RE: Determine Completeness  
High Point Estates, of Adams Road Co.

### **Determination of Completeness of the Subdivision**

Re: High Point Estates: Request for Determination of Completeness of the  
Subdivision.

**Subject: High Point Estates (Adams Road Trust)  
Review of Draft As-Built Plans**

NDL / Sheet 5 -- Golf Ranch sub div 3 31-2026 C1 su

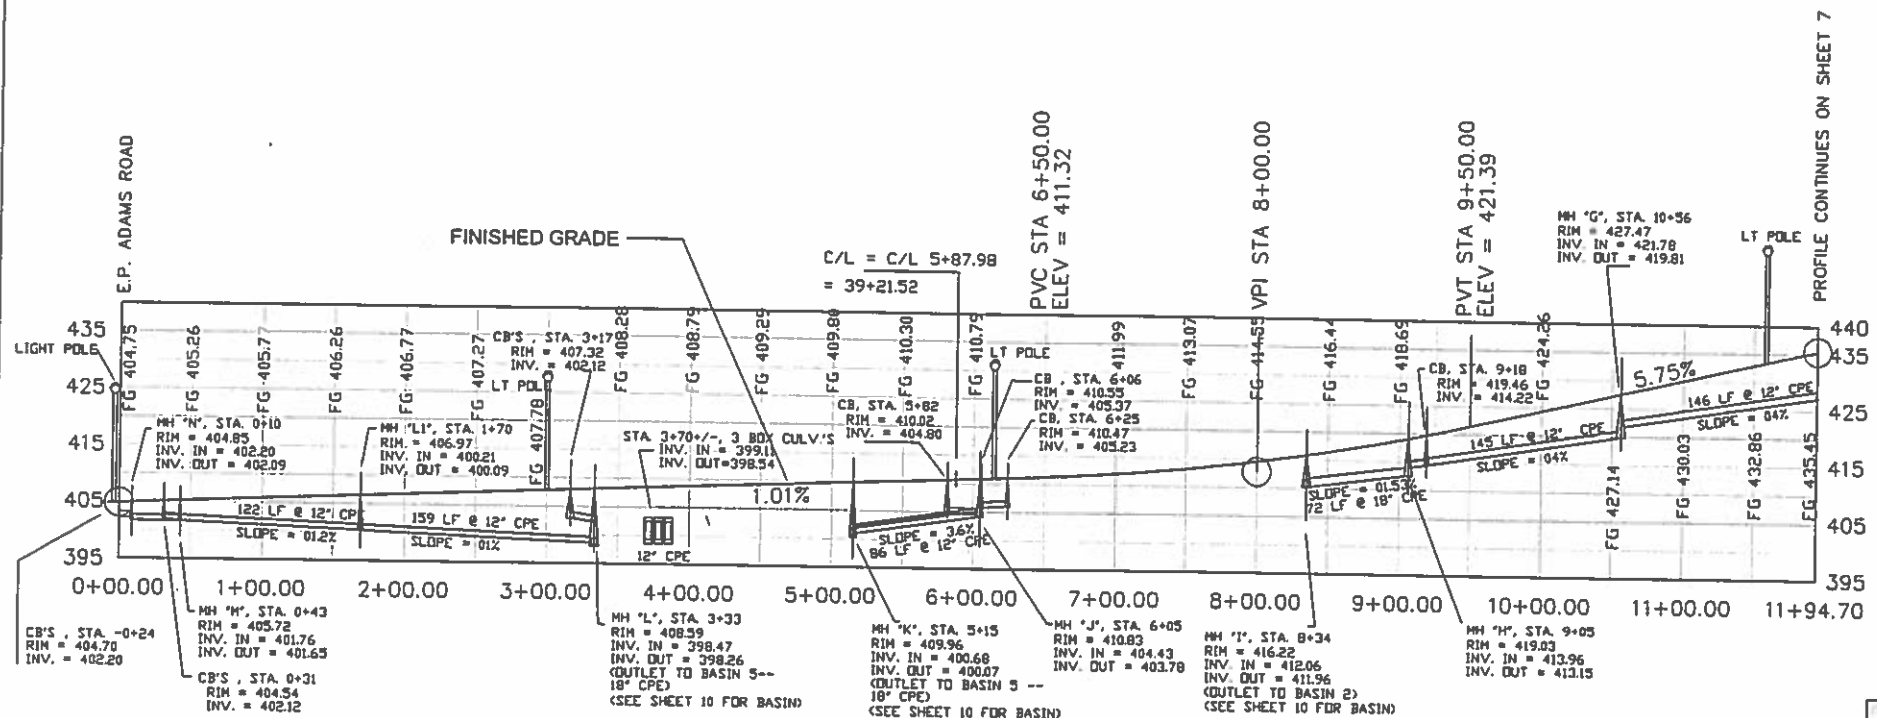
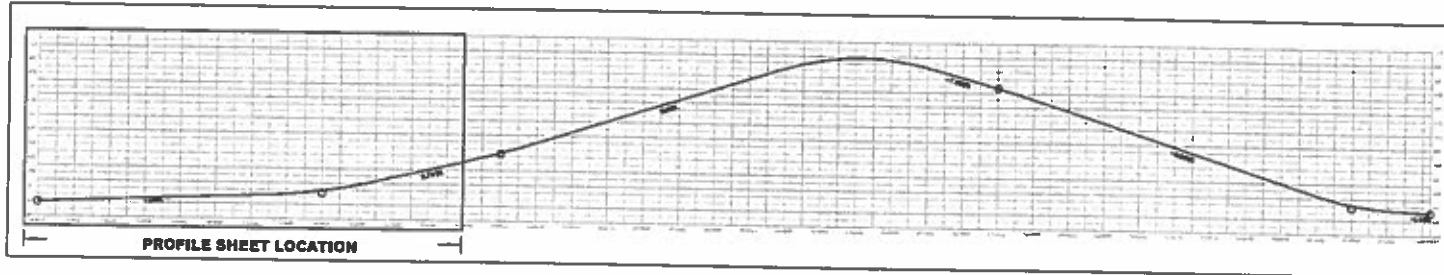
34. On Sheet 5, there appear to be two lots labeled "58" and there is overlapping text on what presumably is Lot 59 that needs to be revised for legibility.

Acknowledged. Sheet 5 was revised accordingly.

ADD | Sheet 7 -- Grapton Road Subd 1-20-2020. pdf (1)

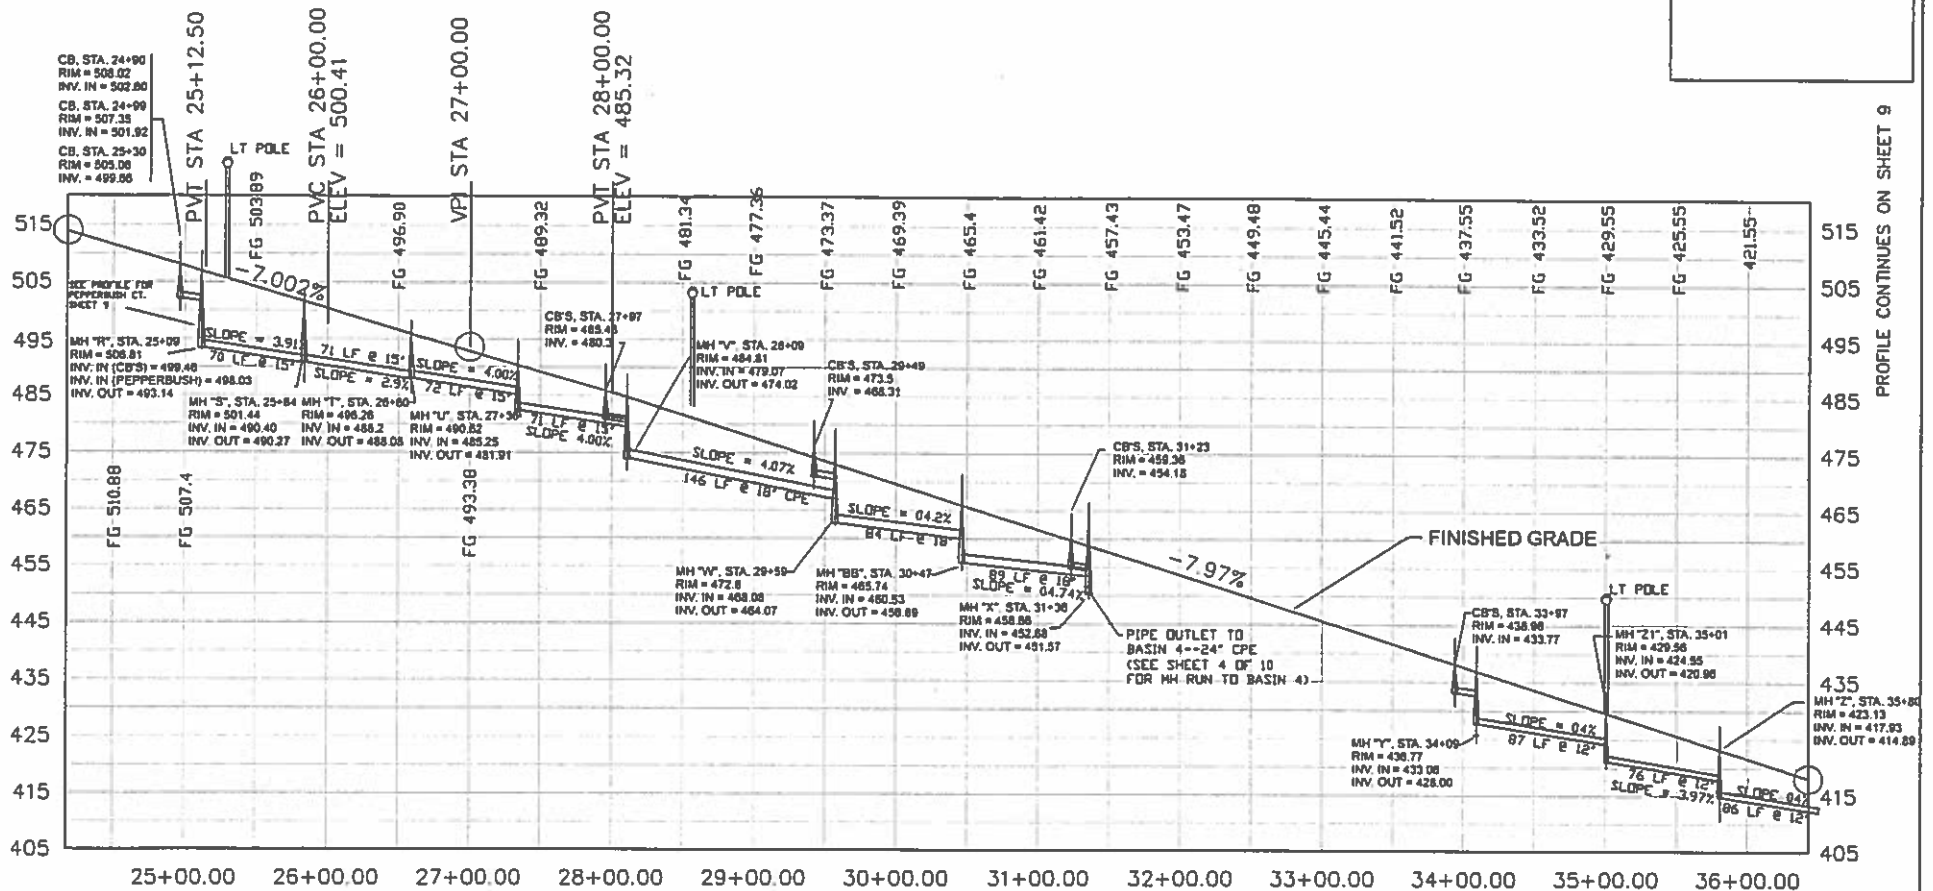
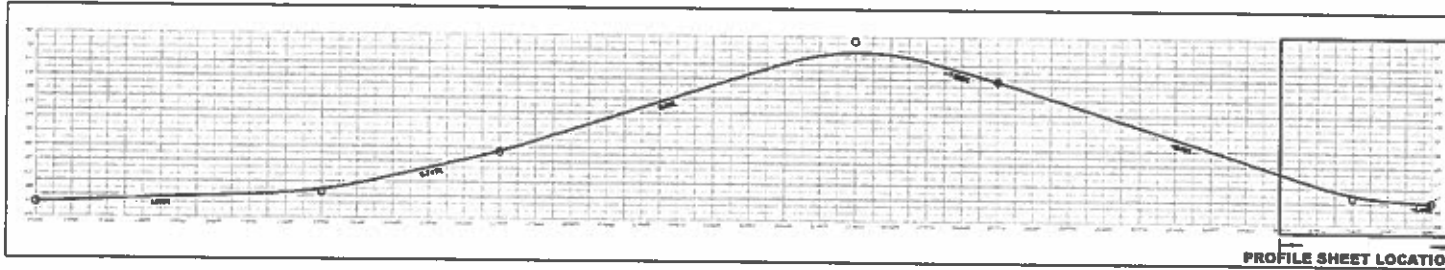
17. On Sheet 7, the label for "MH C" must include the missing inlet invert elevations for the catch basins connected to this manhole.
18. On Sheet 10, there is an inconsistency between the detail of Basin 4 and the layout of the drainage pipes to Basin 4 as shown on Sheet 4. Sheet 10 shows a manhole downstream of "MHX5" before the drainage pipe enters Basin 4. This additional manhole was not shown on the layout view on Sheet 4. If there is a manhole installed (as shown on Sheet 10) the pertinent information (rim and invert elevations) must be provided and the manhole must be included on Sheet 4. If there is not a manhole, as shown on Sheet 10, then Sheet 10 must be revised.

ALL / Sheet 10 - Graft Roads subd 3-30-2020. p16 / 116

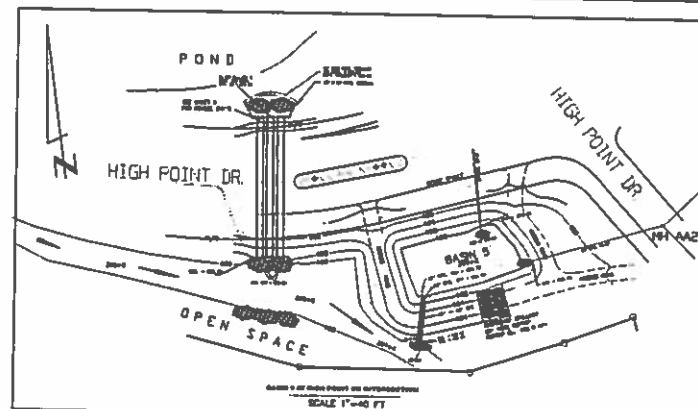
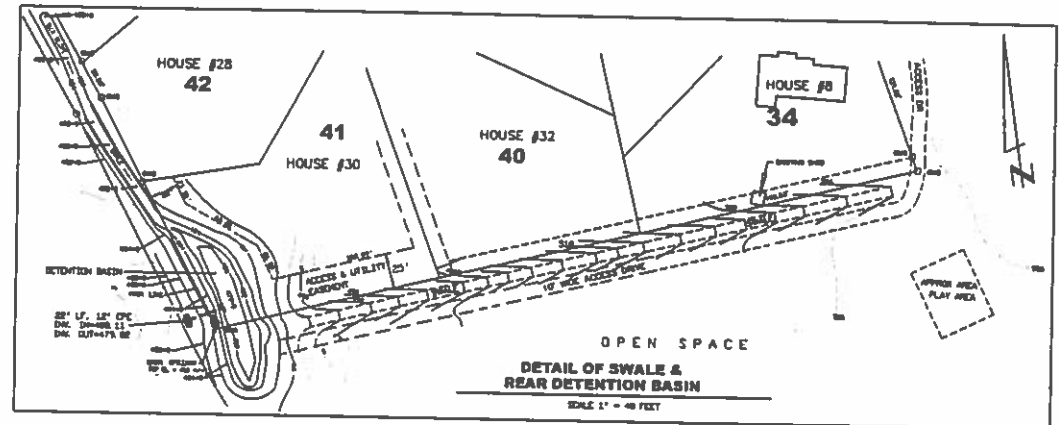
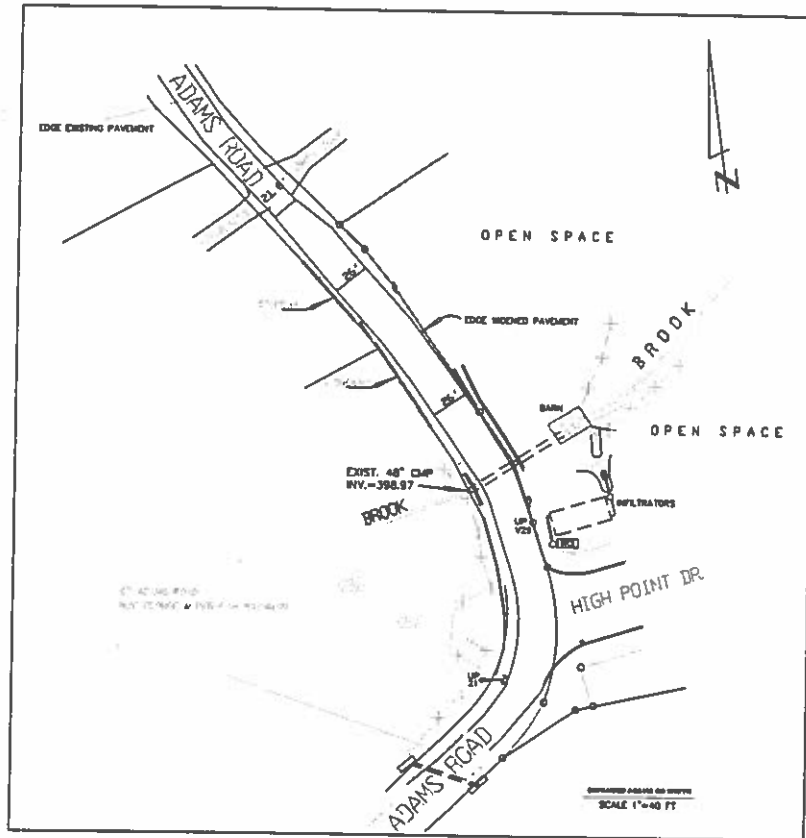
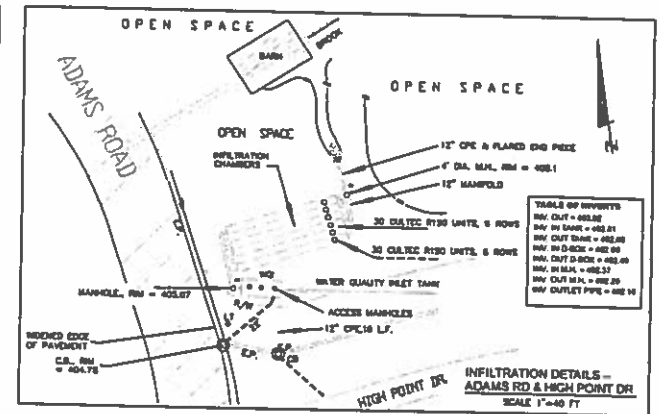
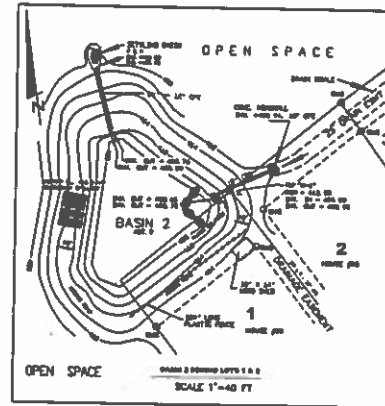
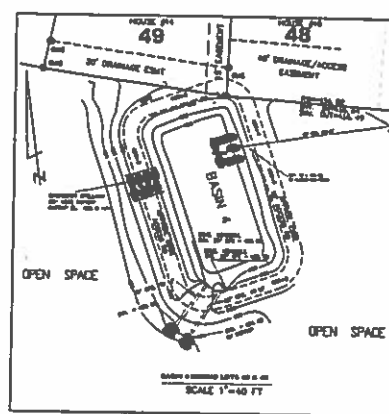
19. On Sheet 10, there are two topographic contours labeled as "483" with leader notes on the "Detail of Swale & Rear Detention Basin" inset. One of these 483 contours was also labeled on Lot 42 as "484" and the other 483 contour lies into the dashed line that represents the 10' Wide Access Drive" on the Open Space (southeast of the detention basin). The line work needs to be corrected and the labels updated as necessary.

20. On Sheet 10, the scale labels for the various insets need to be checked and revised as necessary. Most of the labeled scales appear to be incorrect (e.g. were plotted at 1" = 40' but were labeled as 1" = 20'). Also, on the inset for Basin 4, the easement lines were not drawn to create 20-foot and 40-foot easements (on Lots 48 and 49) as labeled on the inset; the easement lines need to be revised.

18. On Sheet 10, there is an inconsistency between the detail of Basin 4 and the layout of the drainage pipes to Basin 4 as shown on Sheet 4. Sheet 10 shows a manhole downstream of "MHX5" before the drainage pipe enters Basin 4. This additional manhole was not shown on the layout view on Sheet 4. If there is a manhole installed (as shown on Sheet 10) the pertinent information (rim and invert elevations) must be provided and the manhole must be included on Sheet 4. If there is not a manhole, as shown on Sheet 10, then Sheet 10 must be revised.

Sheet 10 has been revised to eliminate the manhole between MHX5 and Basin 4 and elevation labels were added for the manhole. The pipe invert elevations for the manhole show that the outlet elevation is the same as the inlet elevation but as observed during our

ADL CORAF Acceptance - Layout Plans 2020 SHT 3. pag (21 of 21)

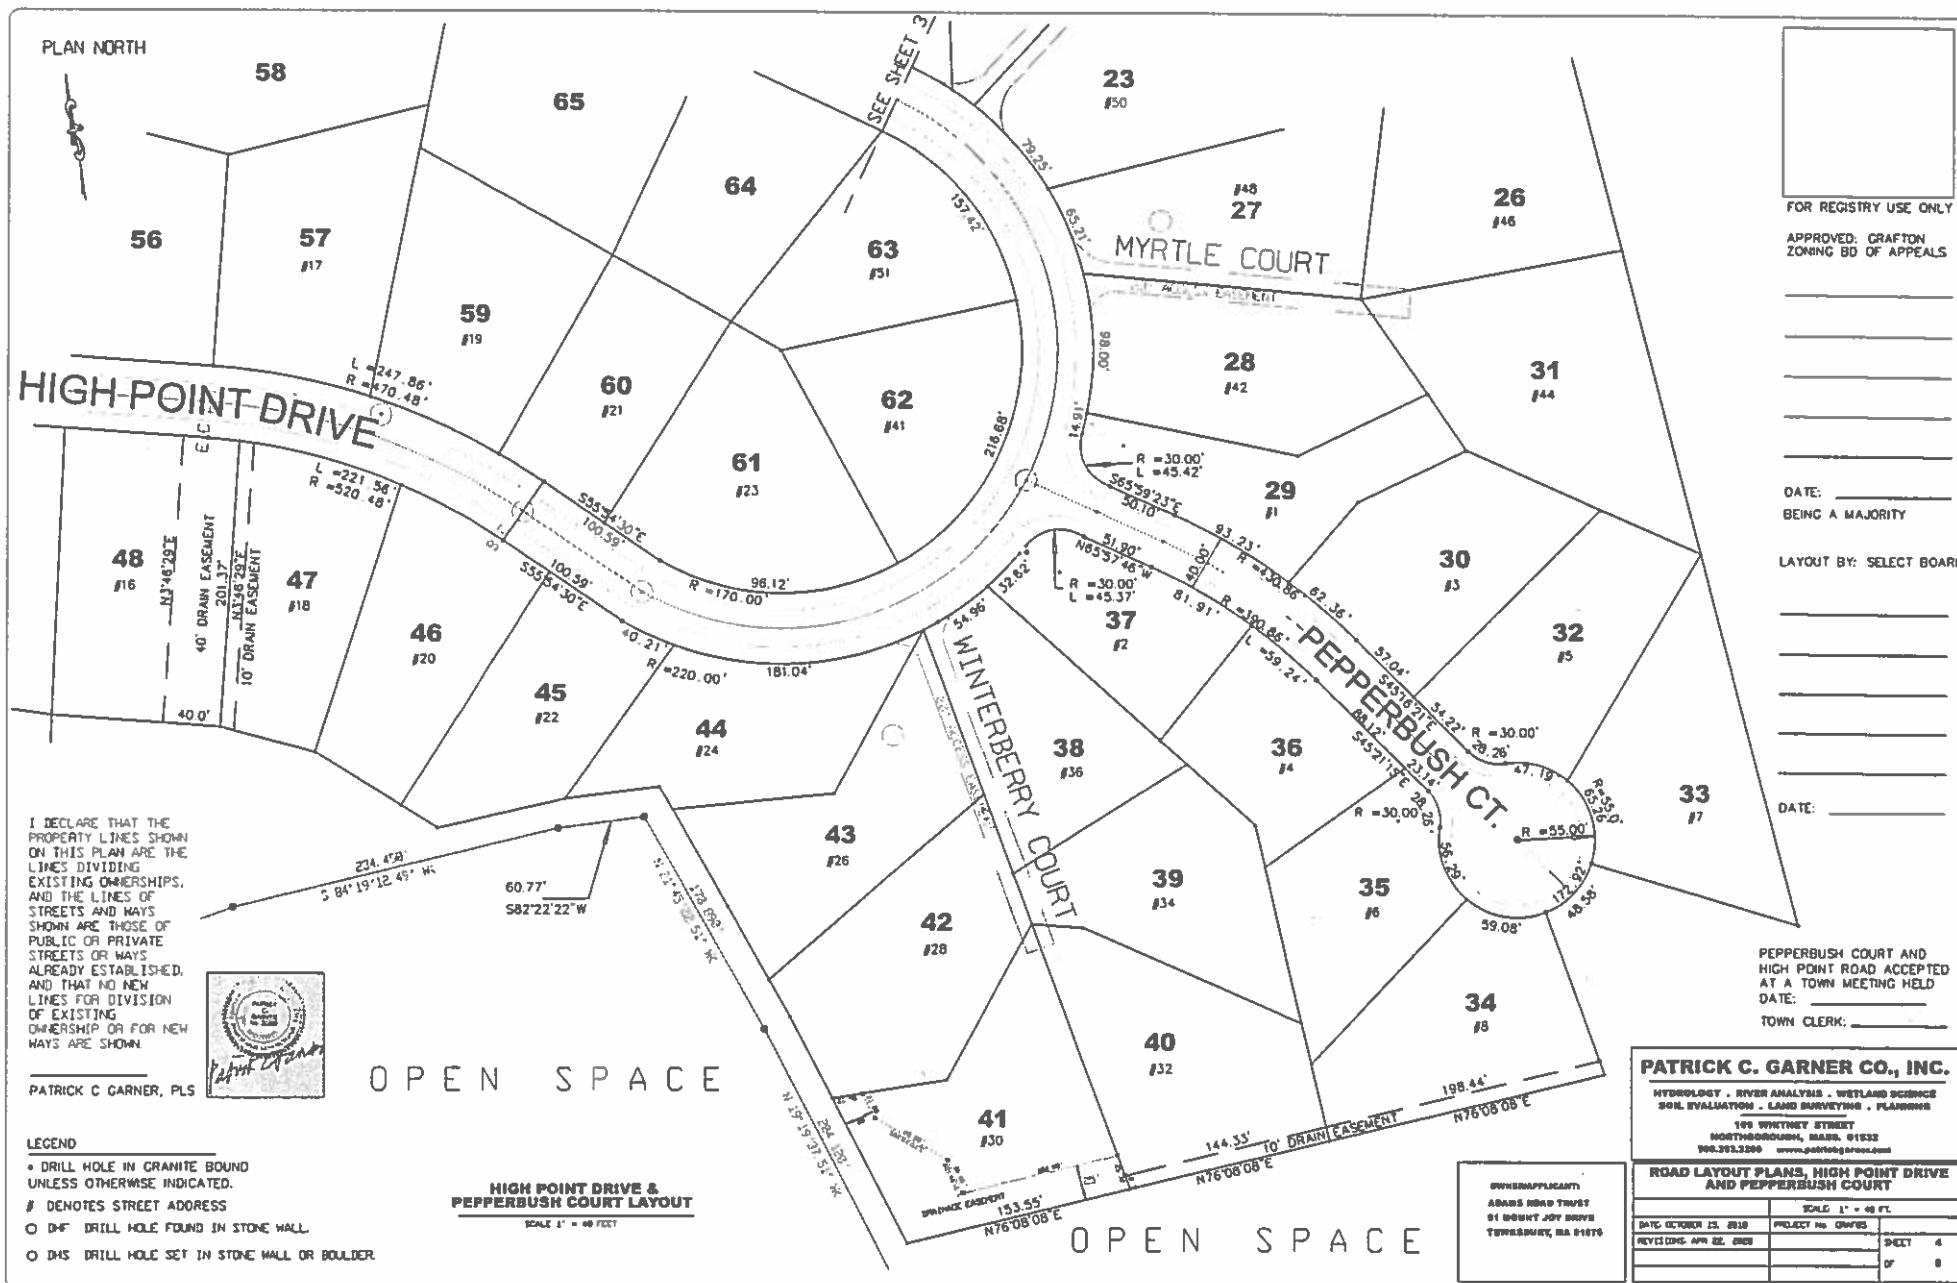
37. On Sheet 3 of the Road Layout Plans, the lines that delineate the access easement on Lots 69 and 70 were omitted from the latest version of the plans.
